CONTOUR APARTMENTS REZONE COVER SHEET

CONTOUR APARTMENTS REZONE
APARTMENTS AND REZONE
COVER SHEET

PW22-018 / PW22-019

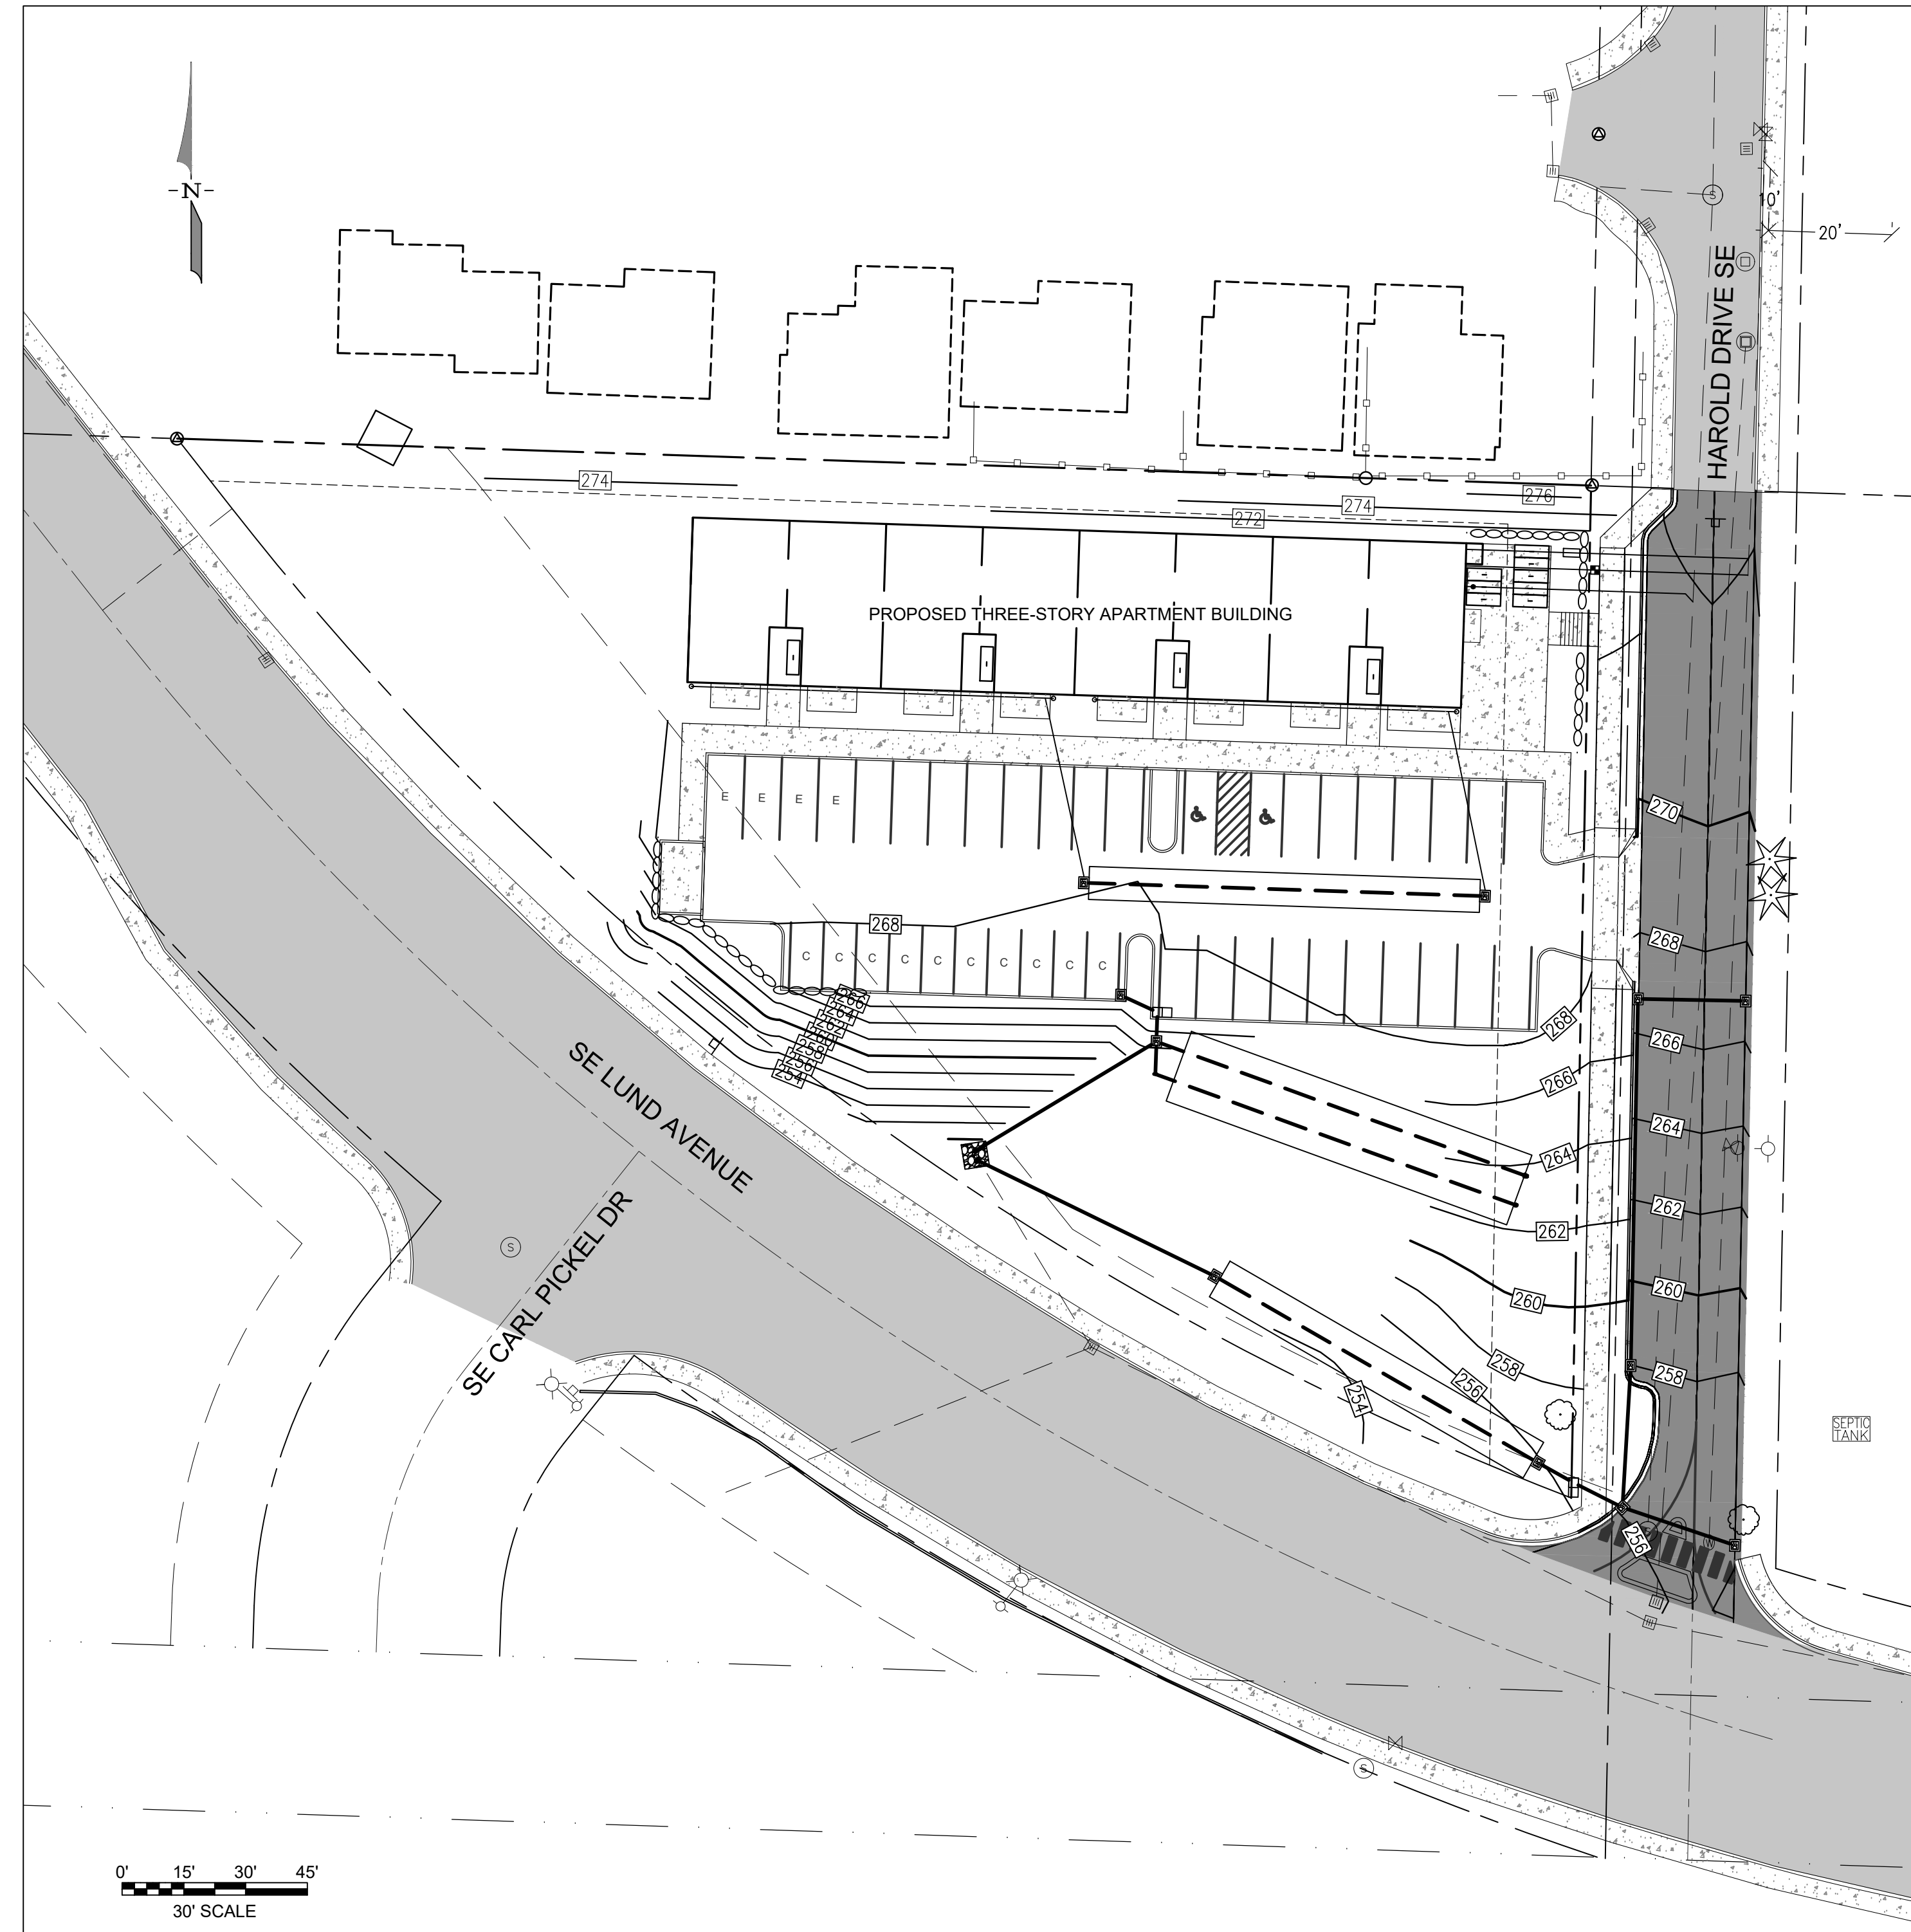
Need a plan sheet with clearing limits and significant trees to be retained with tree protection fencing specifications.

How is the required open space being provided? (POMC 20.127.350)

23 bicycle parking spaces required

POMC 20.32: Parking for Apartments not allowed in front or corner yards

Are all units 2-BR units?

CONTOUR APARTMENTS REZONE SITE PLAN

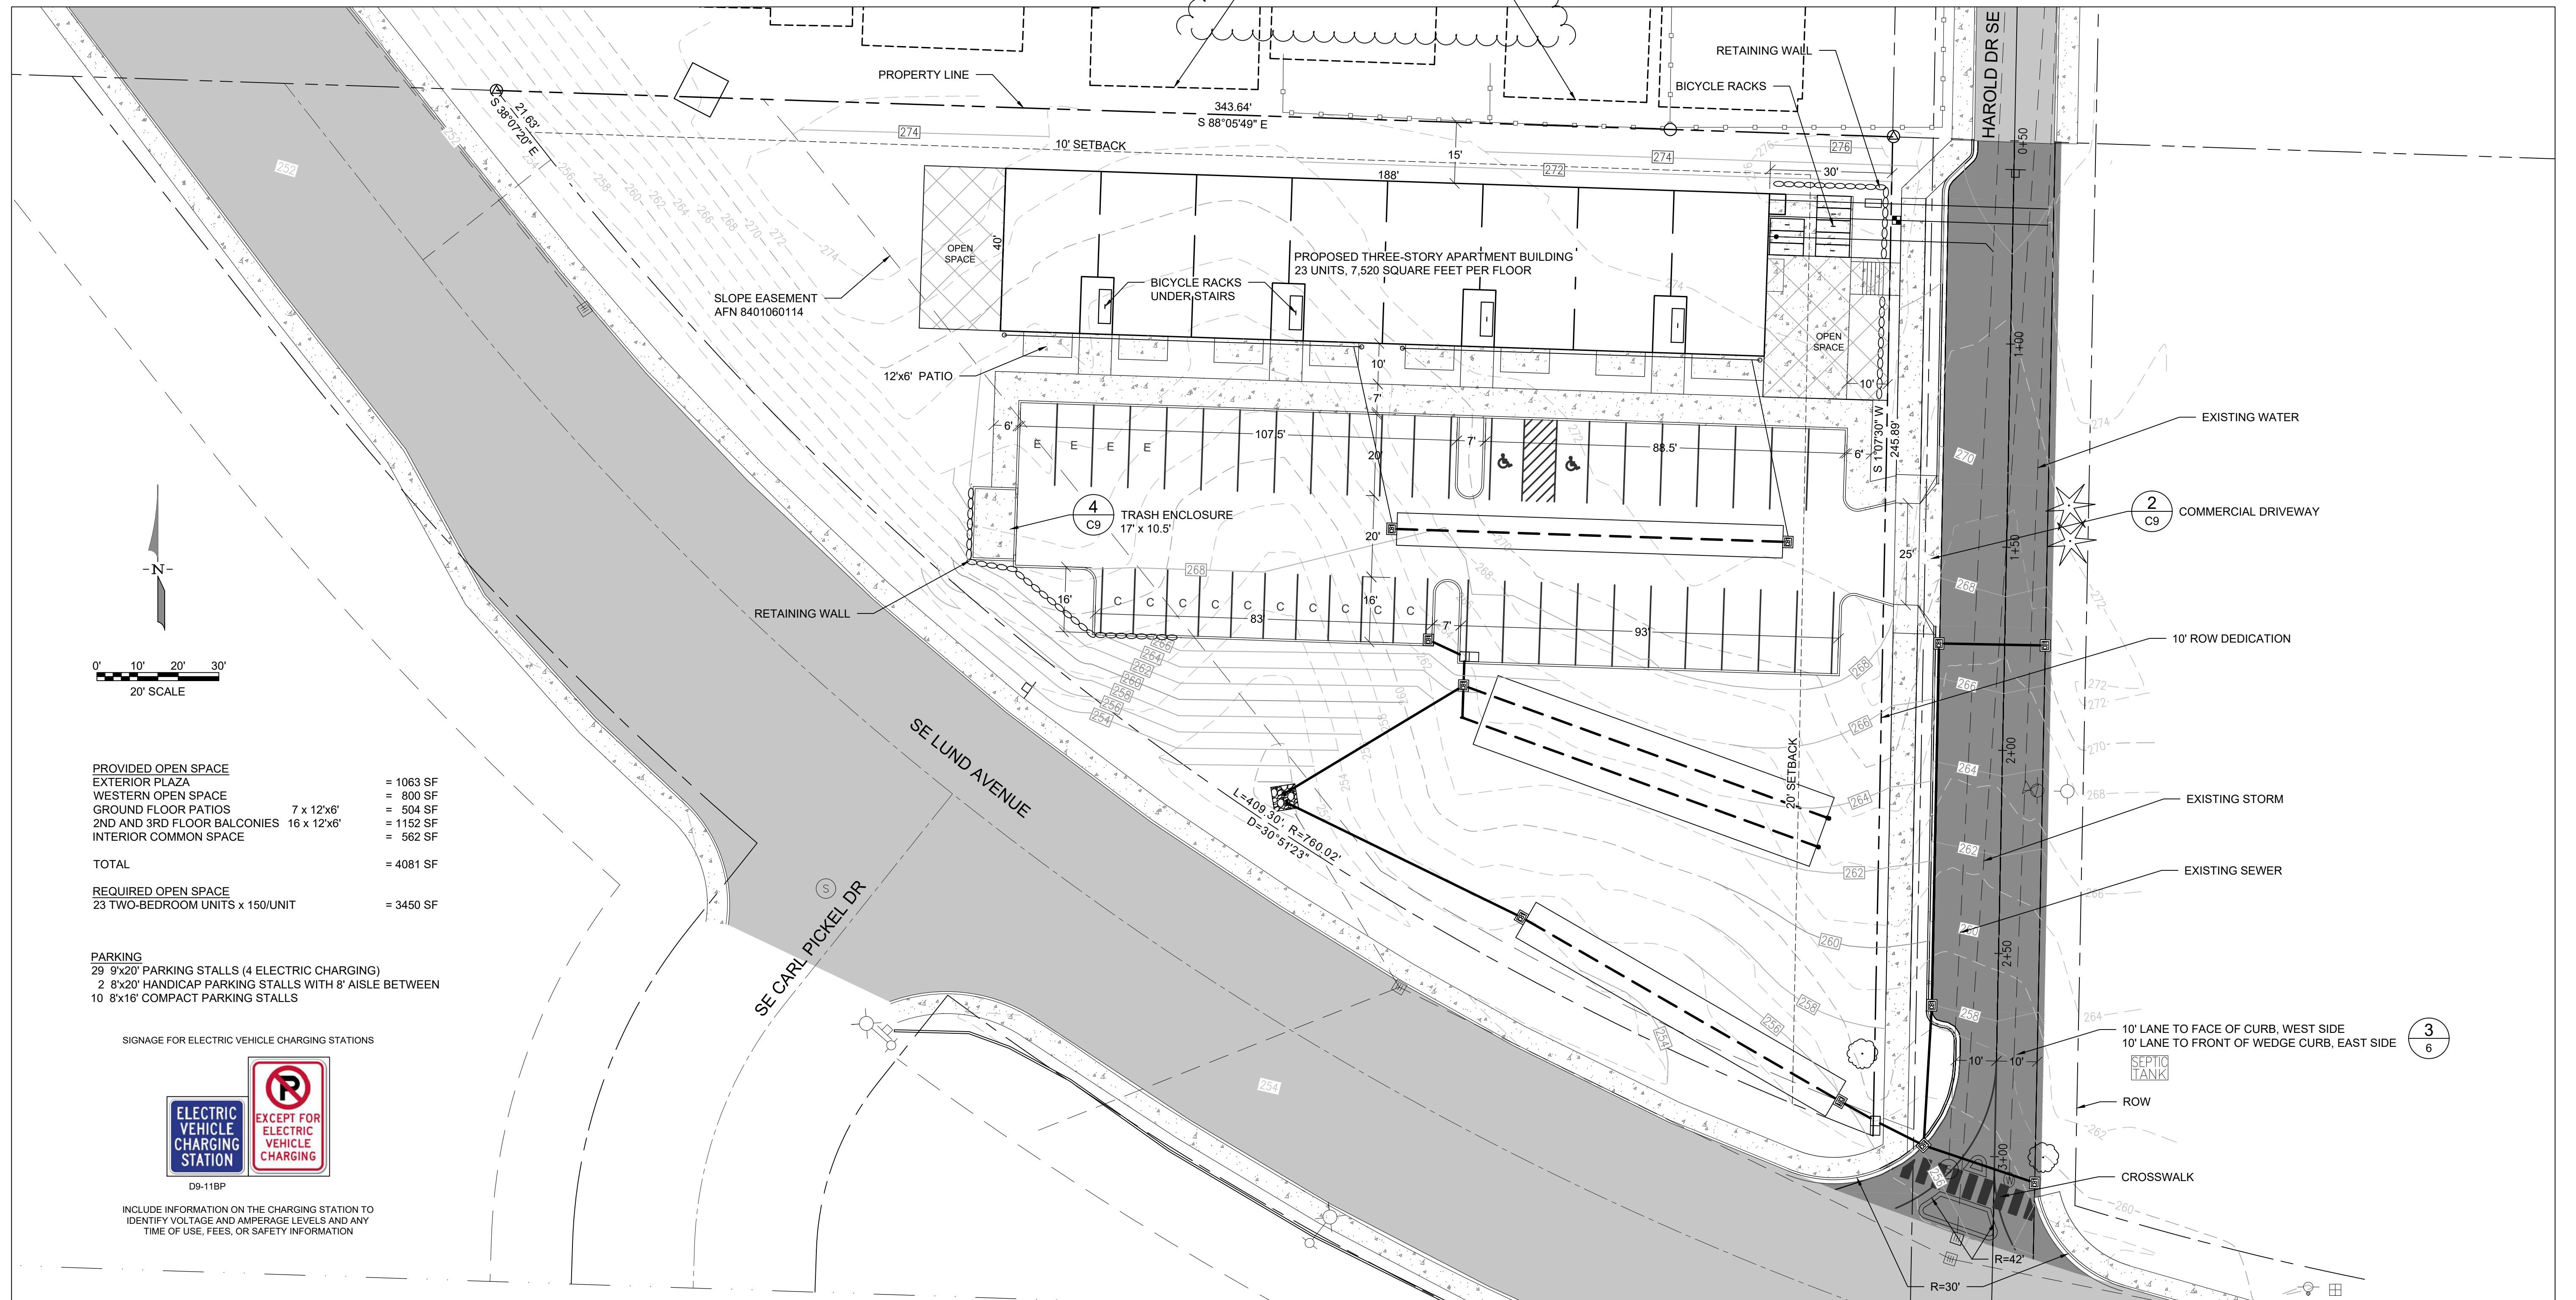
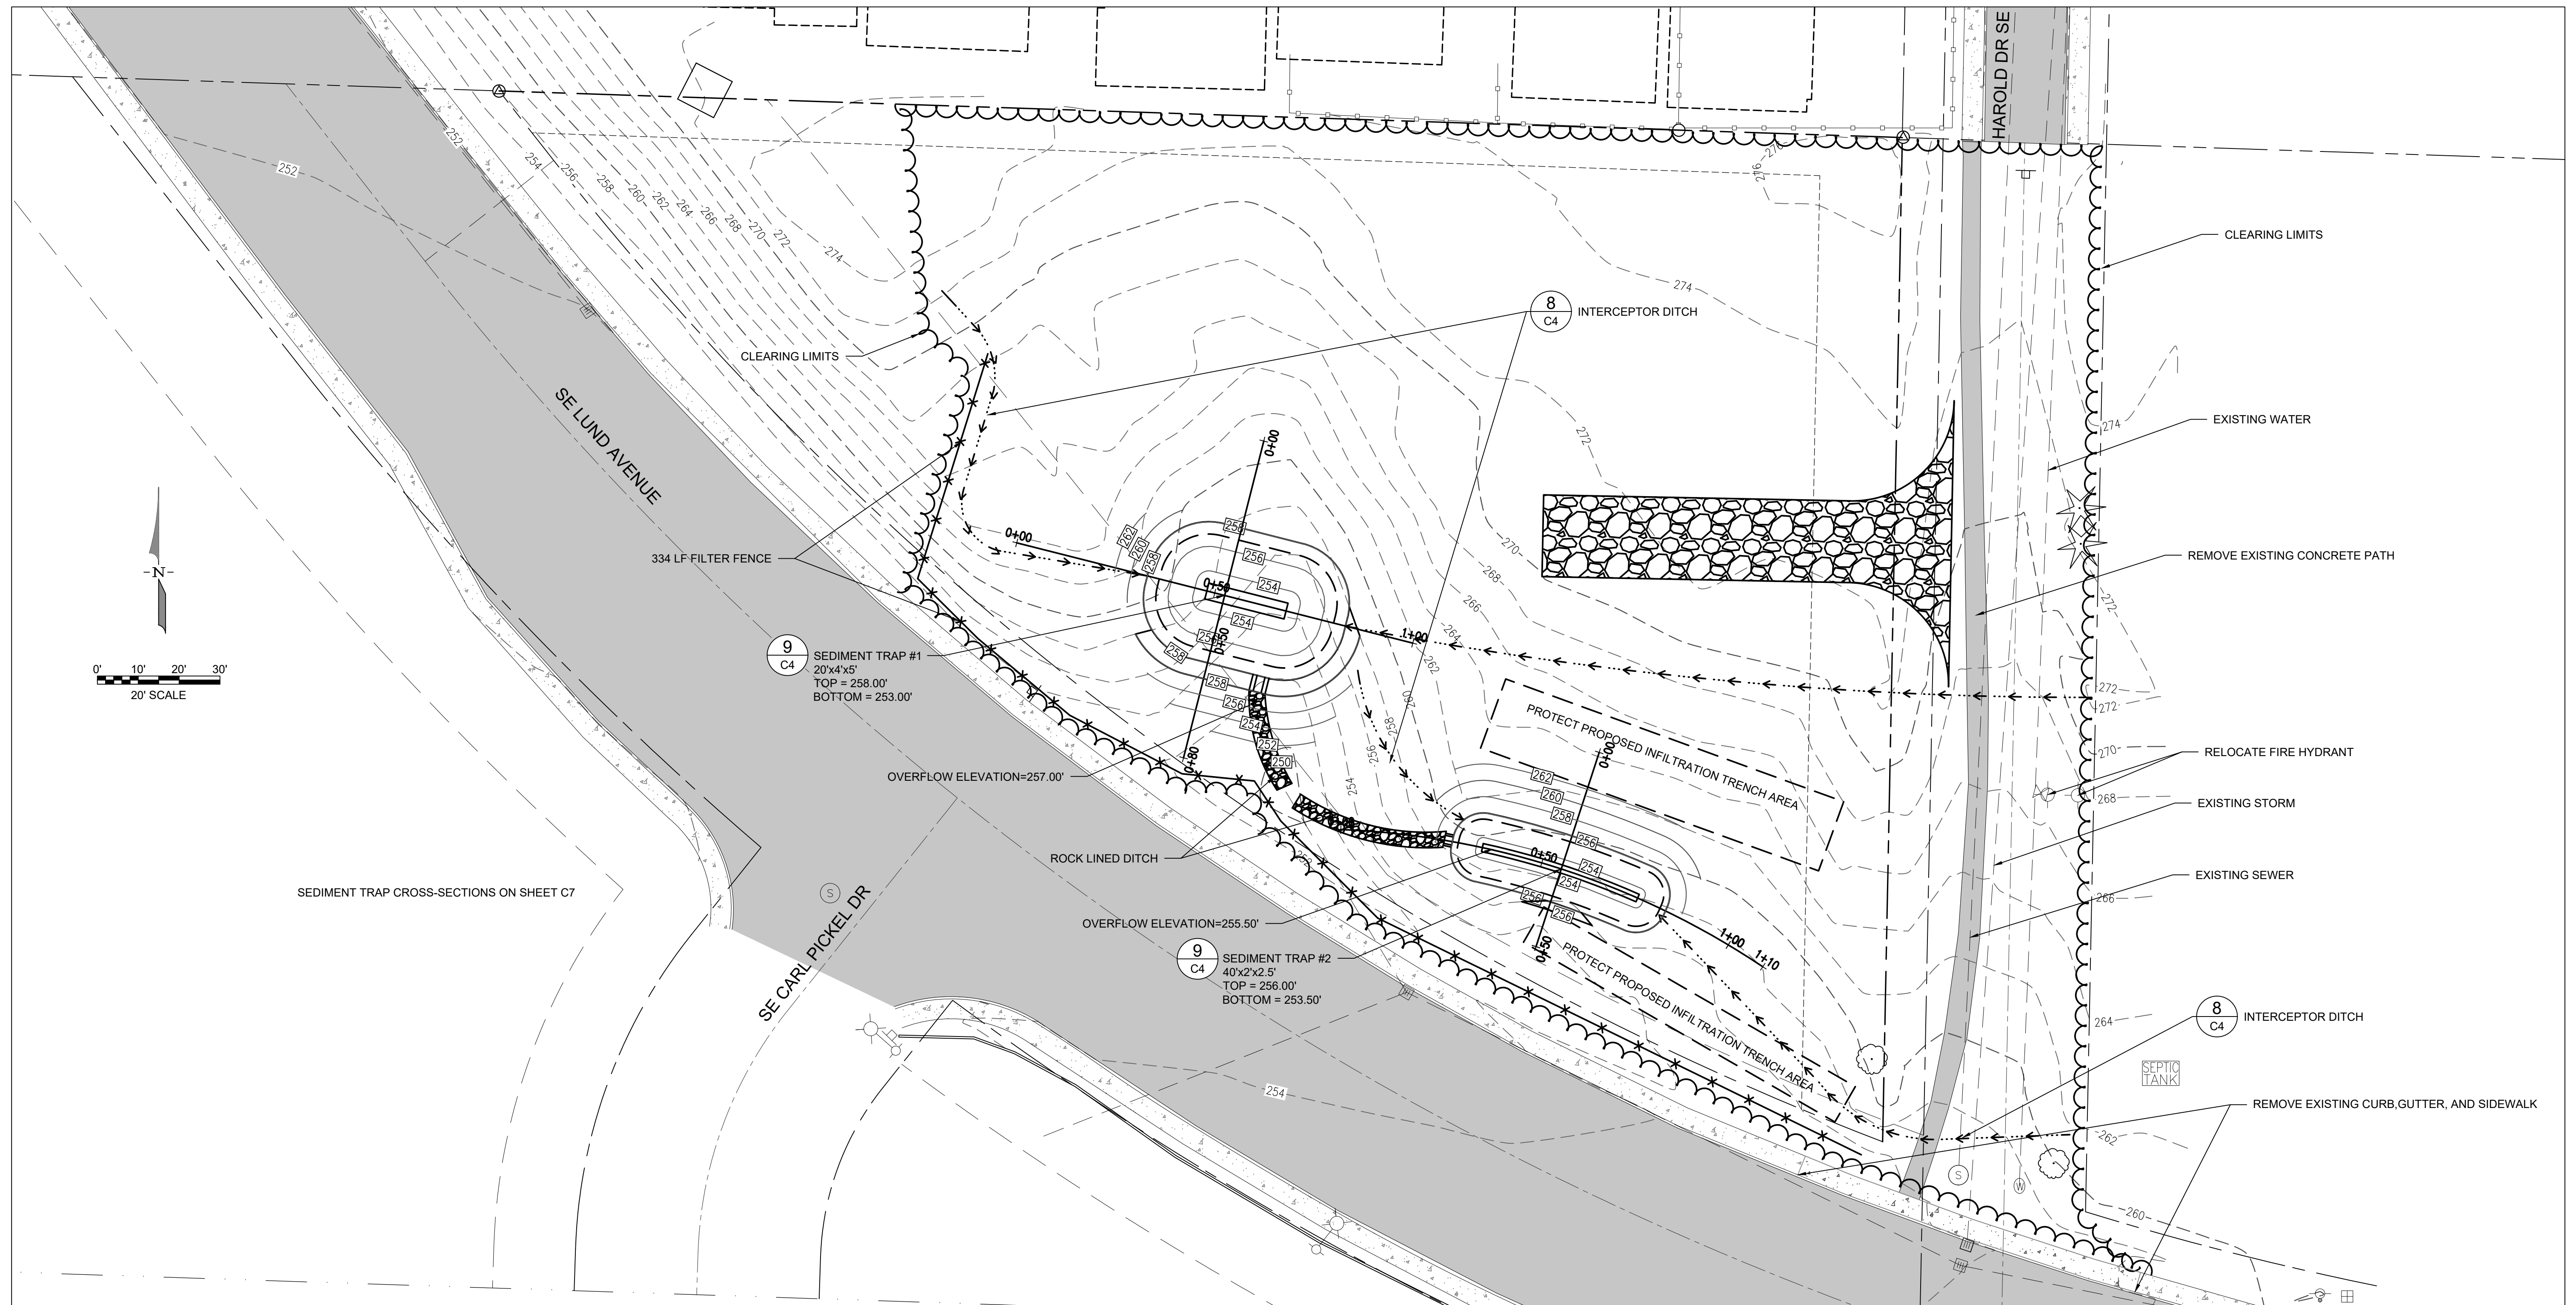
INCLUDE INFORMATION ON THE CHARGING STATION TO IDENTIFY VOLTAGE AND AMPERAGE LEVELS AND ANY TIME OF USE, FEES, OR SAFETY INFORMATION
